1958 Agreement:**Consideration of draft amendments****to existing UN Regulations submitted by GRE****Proposal for Supplement 7 to the original version of UN
Regulation No. 128 (Light emitting diode light sources)****Submitted by the Working Party on Lighting and Light-Signalling***

Supplement 7 to the original version of UN Regulation No. 128 (Light emitting diode light sources)

Figure 1
Enlargement of the nominal emitter box

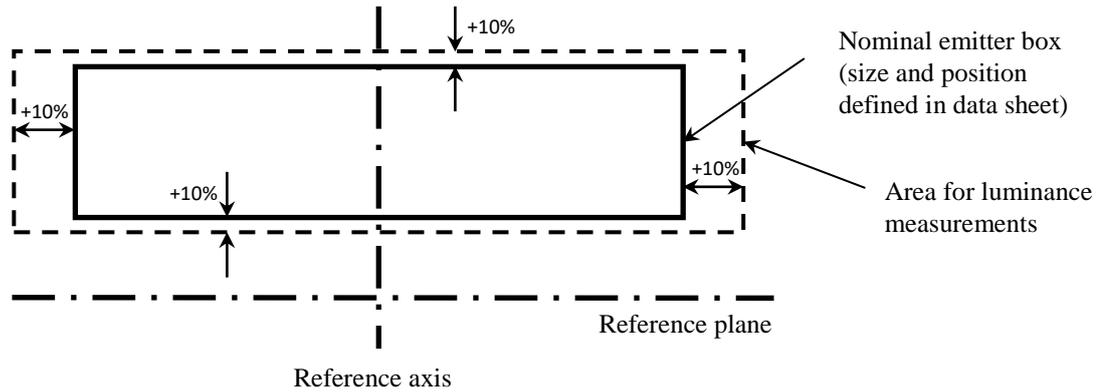
Insert a new Annex 9, to read:

2. The luminance measurements of an area shall be done in an equidistant grid in both directions.
3. Zone 1a and zone 1b shall be determined from luminance measurements of an area which consists of the nominal emitter box as specified in the relevant data sheet of Annex 1 and enlarged to all sides by 10 per cent of the corresponding box dimension (see figure 1). The value L_{98} is the 98th percentile of all values of these luminance measurements.

Figure 2
Definition of zones 1a and 1b

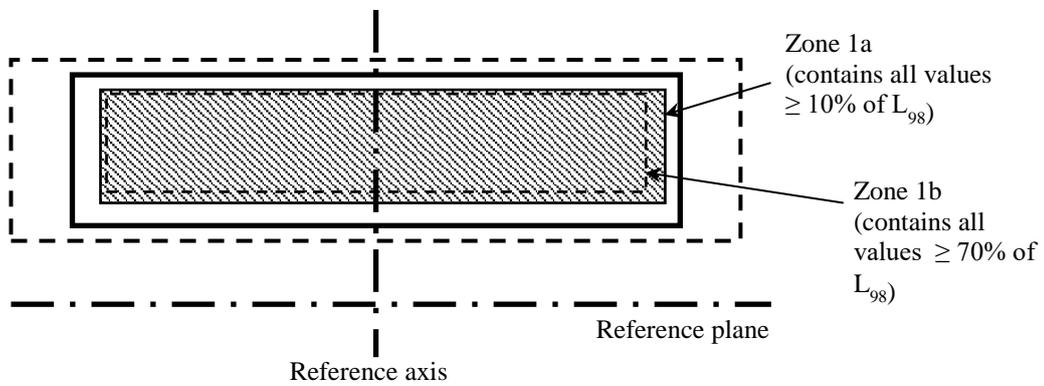
- 3.1. Zone 1a (light emitting area) shall be the smallest circumferential rectangle having the same orientation as the nominal emitter box and containing all luminance measurements with a value of 10 per cent or more of the value L_{98} . The value L_1 shall be the arithmetic average of the values of all luminance measurements in zone 1a (see figure 2). The value of $R_{0.1}$ shall be the surface ratio of zone 1a where the luminance value is exceeding 10 per cent of the value L_1 . The value of $R_{0.7}$ shall be the surface ratio of zone 1a where the luminance value is exceeding 70 per cent of the value L_1 .

- 3.2. Zone 1b shall be the smallest circumferential rectangle having the same orientation as the nominal emitter box and containing all luminance measurements with a value of 70 per cent or more of the value L_{98} .
